# City of Beaumont

## Wastewater Treatment Plant Salt Mitigation Upgrade Project

### Change Order No. 21

September 08, 2021

SHEET 98 OF 172  
**LE-05**

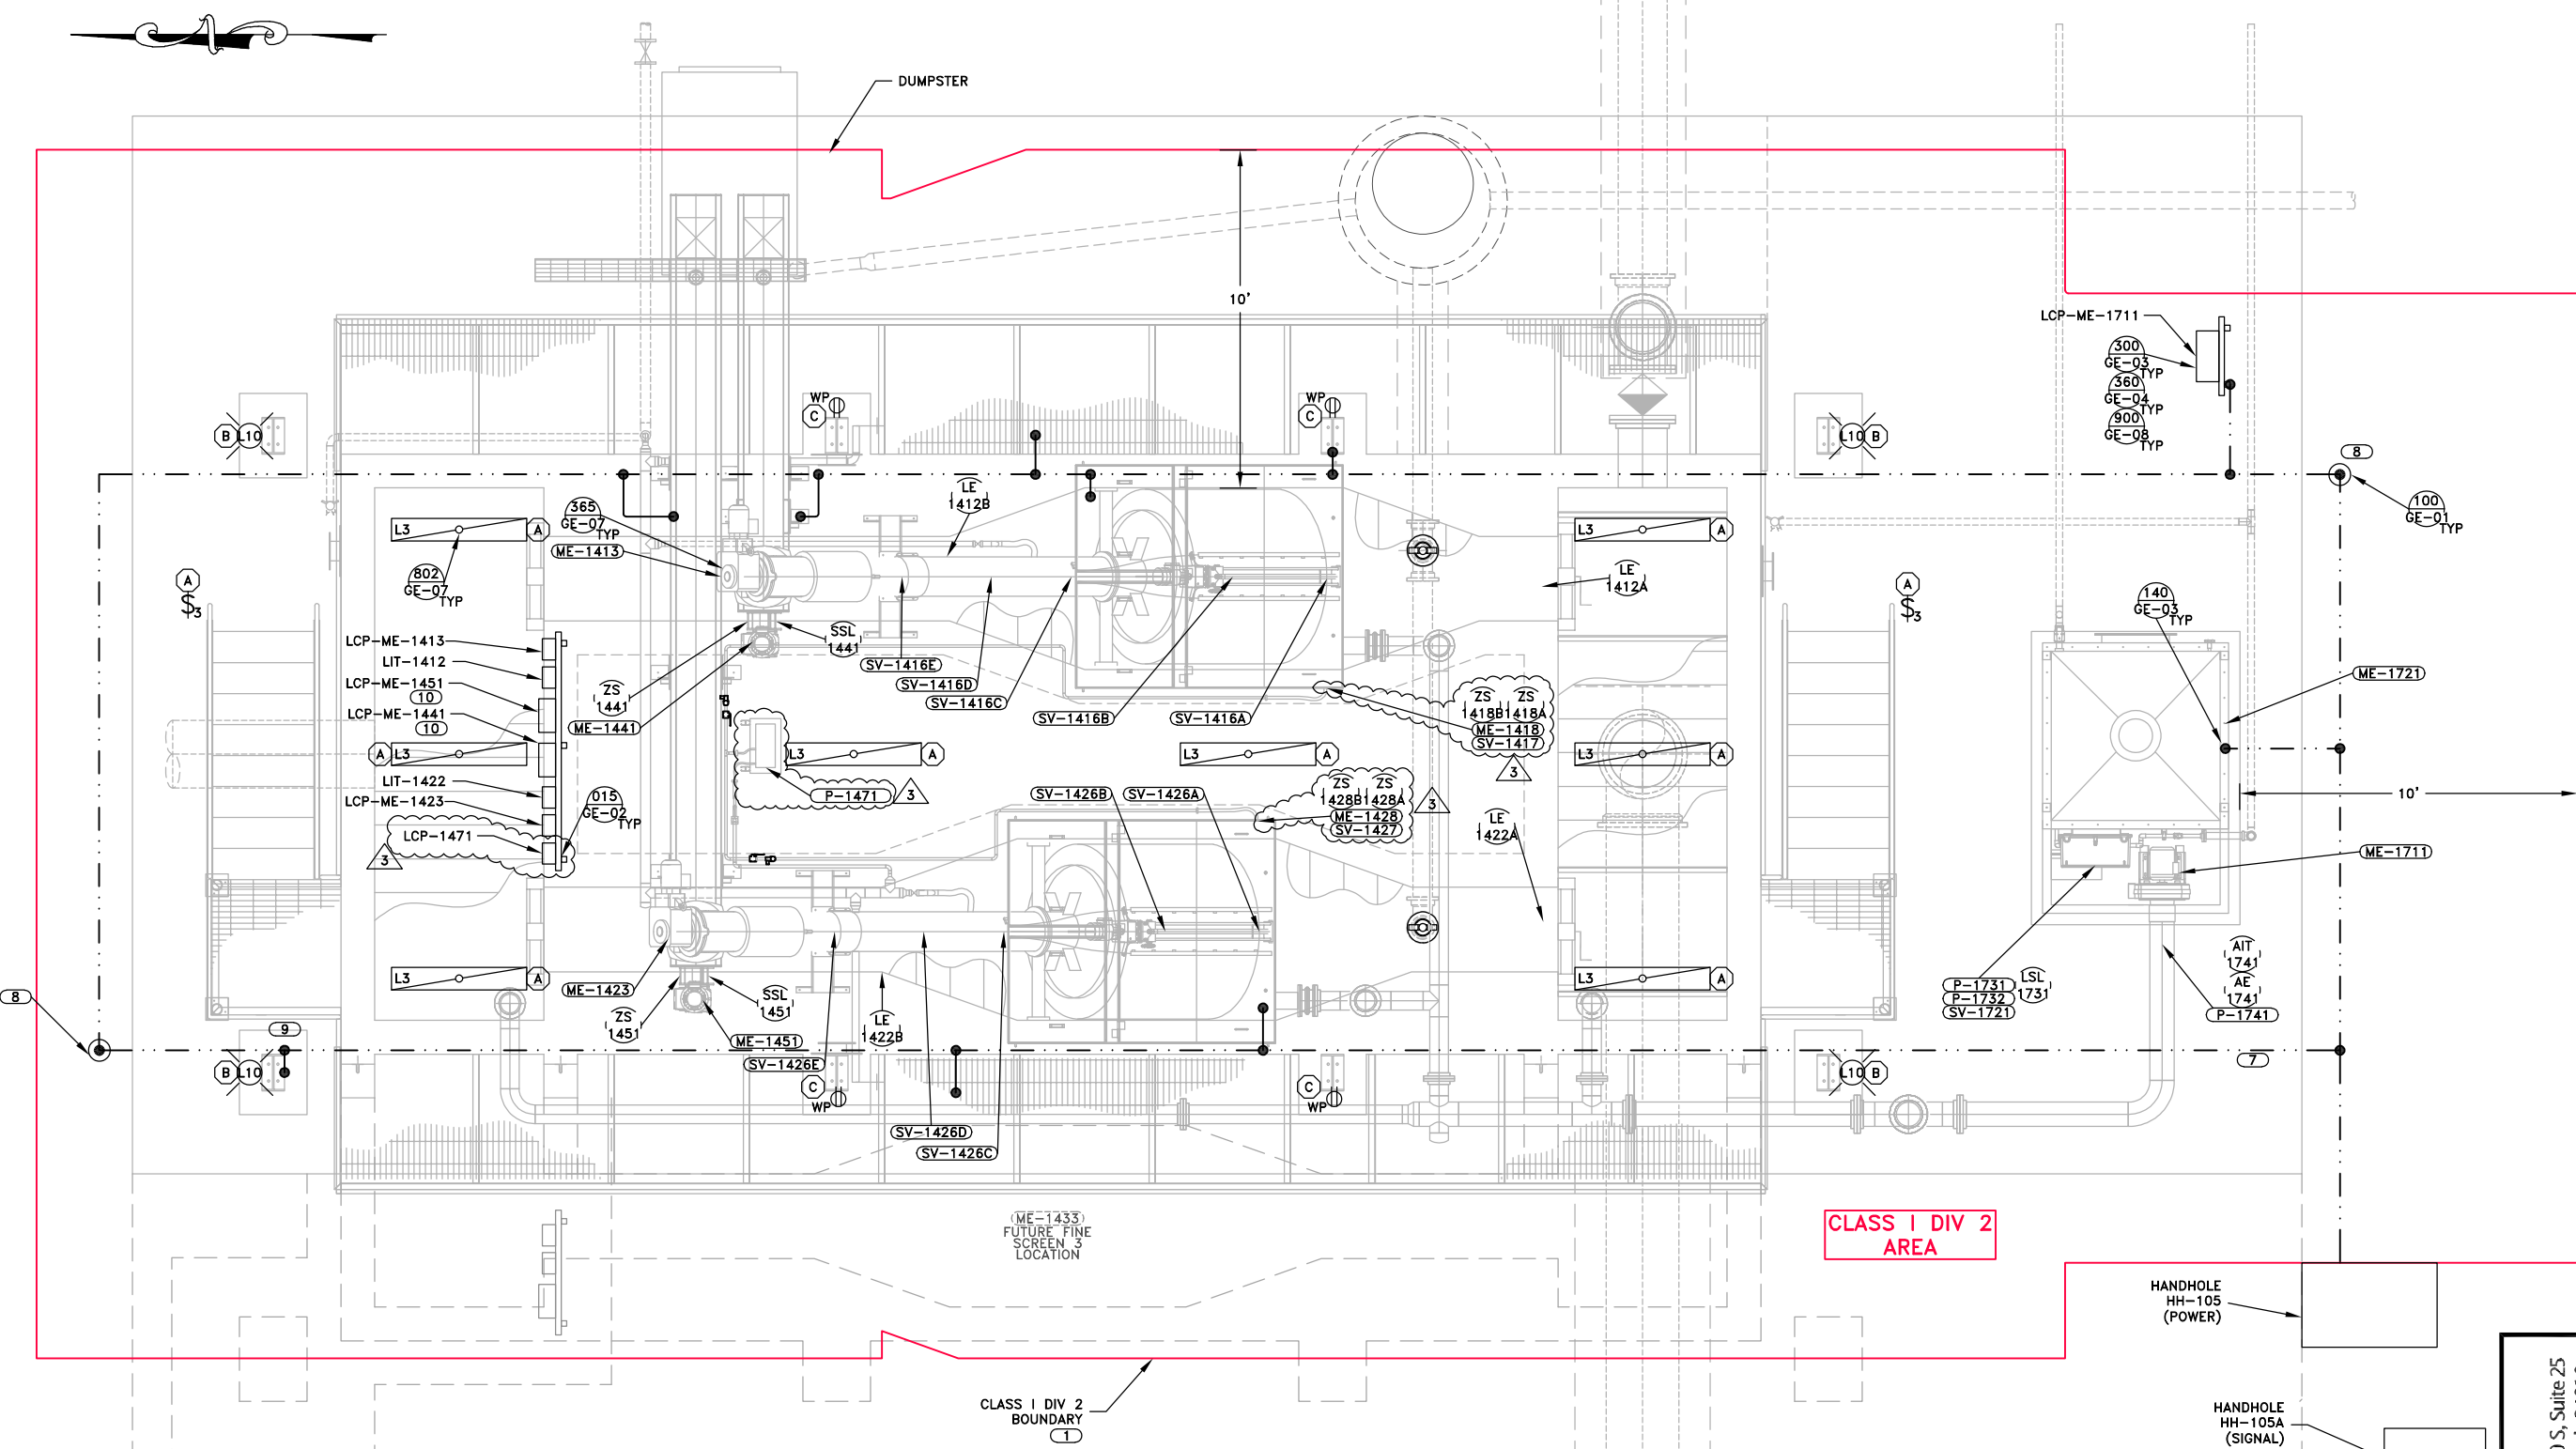
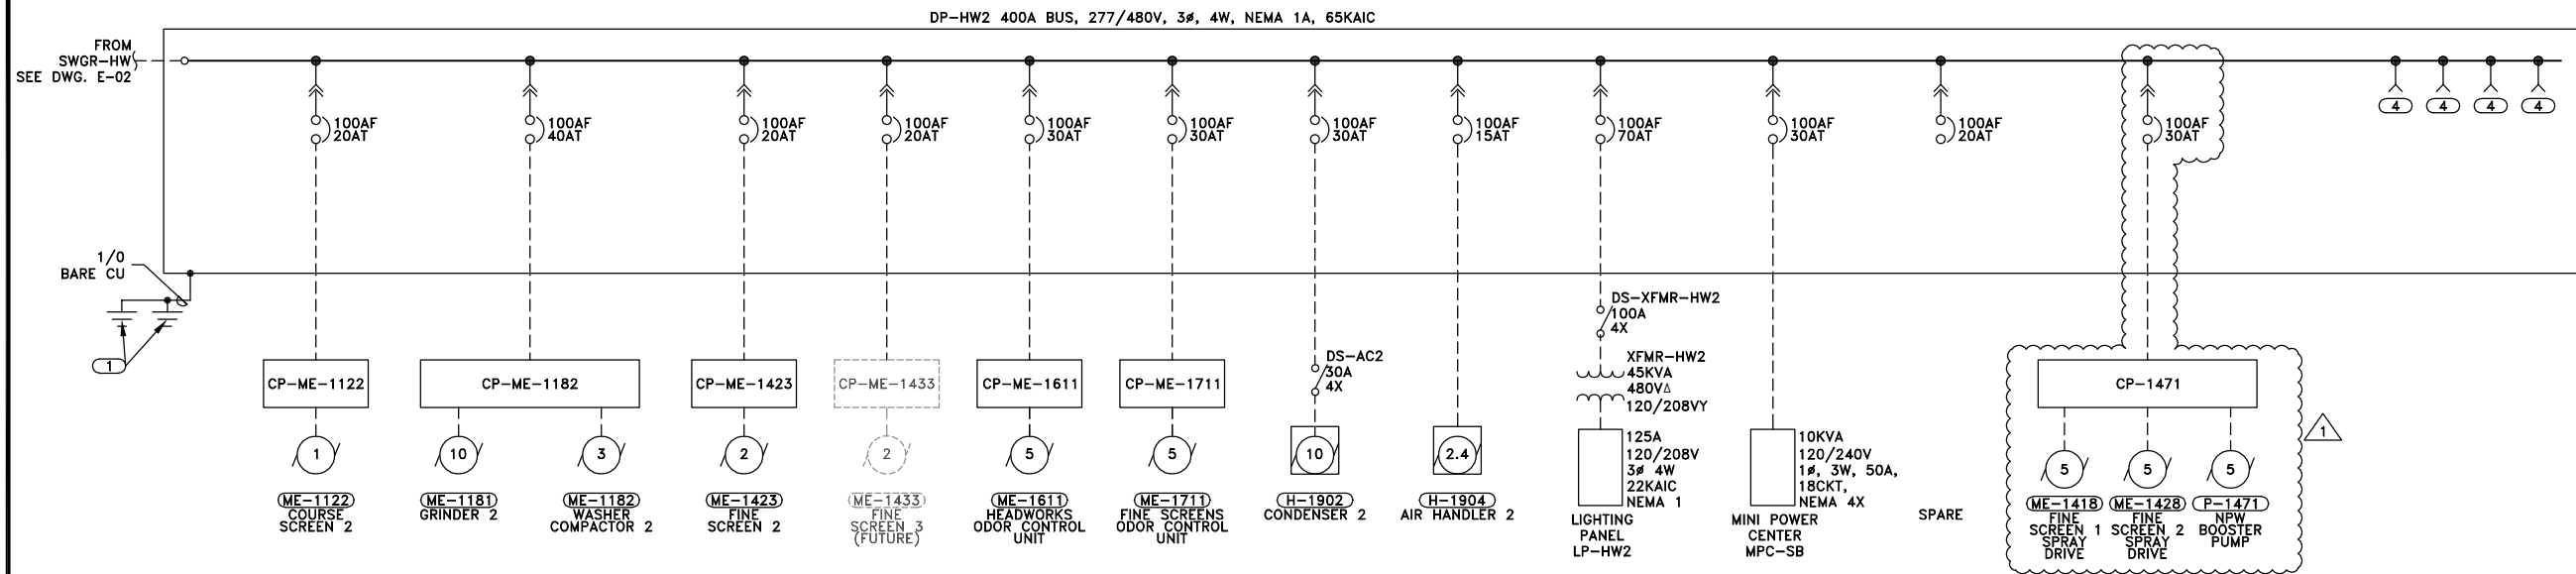
| <p>The new booster pump (P-1471) will be powered and controlled by a 5 hp starter, installed as part of a new control panel, CP-1471. The new fine screen spray motors (ME-1418 and ME-1428) will also be provided with 5 hp starters at CP-1471. Control panel CP-1471 will be located in the electrical building, as shown on drawing LE-01. CP-1471 will be powered from DP-HW2, utilizing a 30AT breaker, as shown on E-04 and E-12. Conduit P1471 (3/4-inch) 3#10 with #12 ground will be added to provide power from DP-HW2 to CP-1471. Spare conduit SP1412 will be repurposed as part of conduit P1471A from the starters in CP-1471 to HH-105. After exiting HH-105, conduit P1471A (1-inch, 9#10 with 3 #12 grounds) will power the new booster pump, P-1471, and the fine screen spray drives, ME-1418 and ME-1428. See LE-05, CE-02, CE-03, CE-10, CE-11, CE-16 and CE-18.</p> |                                    |
